RFI Response - 20 January 2022 757-763 George Street, Haymarket

# RE: RESPONSE TO REQUEST FOR FURTHER INFORMATION – 757 – 763 GEORGE STREET, HAYMARKET

This letter has been prepared on behalf of Samprian Pty Ltd (the Applicant) in relation to their land at 757 – 763 George Street, Haymarket (the site). The site is the subject of a Planning Proposal (PP ref no PP-2020-1110.) that seeks to amend the height of buildings and floor space ratio (FSR) development standards that apply to the site under the *Sydney Local Environmental Plan 2012* (Sydney LEP 2012). The purpose of this letter is to respond to the matters raised by the City of Sydney (Council) in their Request for Information letter dated 12 November 2022.

Figure 1 - Wind testing locations and compliance with wind comfort and safety criteria

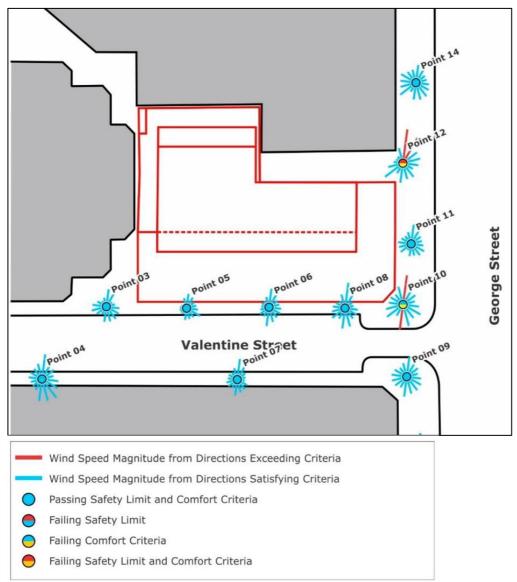
**Issue (summary):** The proposed envelope results in a windy environment, including two locations with a wind comfort rating of 'uncomfortable' and an exceedance of the wind safety standard. While meeting the average wind criteria is important, it is not the sole determinant of an appropriate response to wind. Accordingly, it is recommended that additional wind testing is undertaken to identify opportunities for wind mitigation including amending the planning envelope geometry, to help calm these locations.

Council identified that two testing locations fail to meet the wind comfort rating and exceed the wind safety standard. These testing point locations consist of **Point 10** and **Point 12** which are identified in **Figure 1** below.

The wind testing results conclude that Points 10 and 12, as shown in **Figure 1** below, exceed the relevant criteria thereby resulting in a minor non-compliance with Section 5.1.9. Specifically:

- Point 10 provides a minor exceedance to the wind speed comfort criteria; and
- Point 12 provides a minor exceedance to the wind speed and safety criteria.

Notwithstanding the above, the proposal complies with Procedure B, Schedule 11. Schedule 11, Procedure B(4) requires that proposals when compared against a compliant base case envelope are 'to demonstrate equivalent (improved) wind comfort, wind safety and daylight levels in adjacent Public Places relative to the base case building massing. For wind speed the comfort values should be averaged and compared. When averaged, the proposal, relative

to a complying base case, complies with the wind speed comfort and wind speed and safety criteria.

- Windtech have undertaken further wind testing (**Appendix 2**) to assess whether the proposal is capable of complying with Section 5.1.9. The results confirm that the proposal, and specifically Points 10 and 12, is capable of achieving full compliance with the applicable wind provisions subject to minor design changes and mitigation measures, including the existing heritage awning and a small building chamfer along the north-eastern corner of the podium. These are discussed further below.

# 01 - Wind results

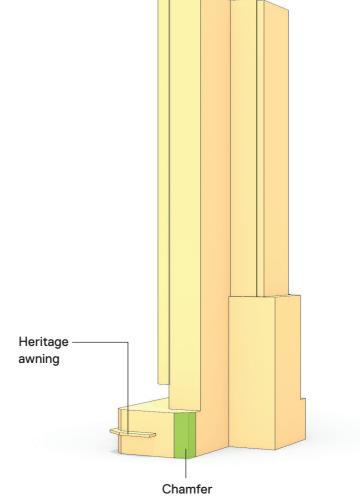
Two locations with a wind comfort rating of 'uncomfortable' and an exceedance of the wind safety standard.

Additional wind testing to identify opportunities for wind mitigation, including amending the planning envelope's geometry to help calm these locations.

As requested by Council we have undergone further wind tunnel testing to prove how the envelope can achieve compliance and eliminate the minor exceedences to Points 10 and 12.

Windtech's study proved that Point 10 will be pass with the inclusion of the heritage awning above.

For Point 12, a small chamfer at the podium level of  $3.58 \,\mathrm{m} \times 3.58 \,\mathrm{m}$  is enough to make the test point compliant. It is worth noting that this area has already been removed in the indicative scheme and as such would not have an impact on the available FSR.

# Schedule 12 Comparison

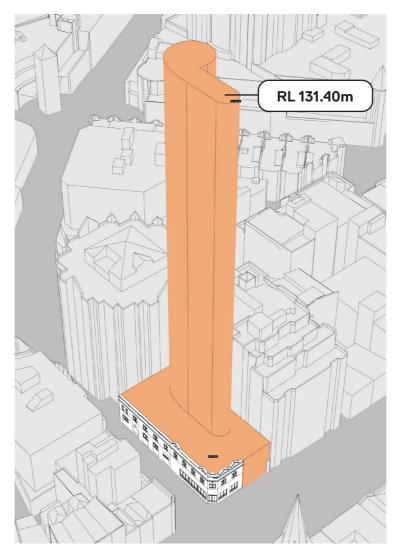
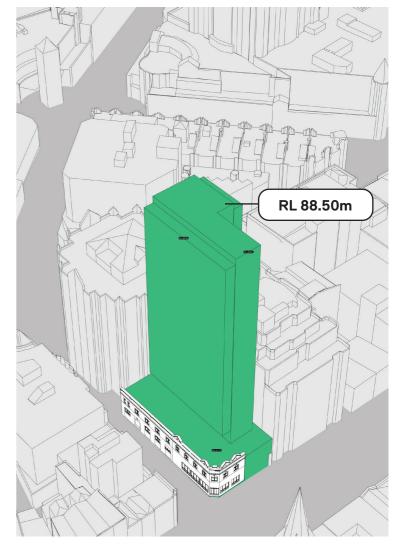
**Issue (summary)**: Overall, the revised planning envelope is highly constrained and does not include sufficient flexibility to address environmental amenity issues. In particular, the planning envelope does not meet the architectural articulation quotient of include a suitable façade zone as required by the draft Central Sydney DCP.

In the amended information, the locations identified as architectural articulation are not actually located within the proposed envelope and therefore cannot be accepted. It is recommended that a minimum of 15% architectural articulation is included within the proposed planning envelope, calculated per floor to ensure there is sufficient flexibility within the envelope on each floor, not volumetrically. Further an appropriate façade zone for sun shading is to be included.

As requested by Council we undertook additional Schedule 12 analysis to compare the scheme against the current regulation.

For consistency the proposed envelope maintained the same setbacks as lodged October 2021.

While the updated regulation allows for an articulation zone of 8% inclusive of facade zone for buildings up to 120m, the requirement for filleting to all corners of the base case massing reduces the envelope significantly.

Table 2: Wind Tunnel Results Summary – Point 12

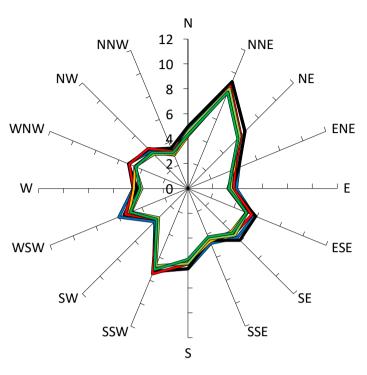
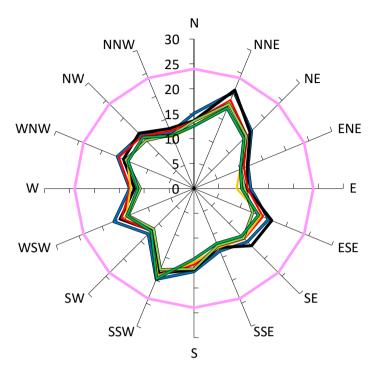
The results of the wind tunnel study are presented in the form of directional plots in Appendix A for study point locations 10 and 12, and summarised in Tables 1 and Table 2.

- Modification 1 With the inclusion of the heritage awning and without the building chamfer on the north-east corner.
- Modification 2 With the inclusion of the heritage awning and a large building chamfer along the north-eastern corner of the podium.

- Modification 3 With the inclusion of the heritage awning, a double storey cut-out at level 10 along the northern façade and without the building chamfer on the north-east corner.

- Modification 4 With the inclusion of the heritage awning, a double storey cut-out at level 10 along the northern façade and a small building chamfer along the north-eastern corner of the podium.

- Modification 5 With the inclusion of the heritage awning, a double storey cut-out at level 10 along the northern façade and a large building chamfer along the north-eastern corner of the podium.

- Modification 6 With the inclusion of the heritage awning and a corner cut out along the northeastern corner of the podium.
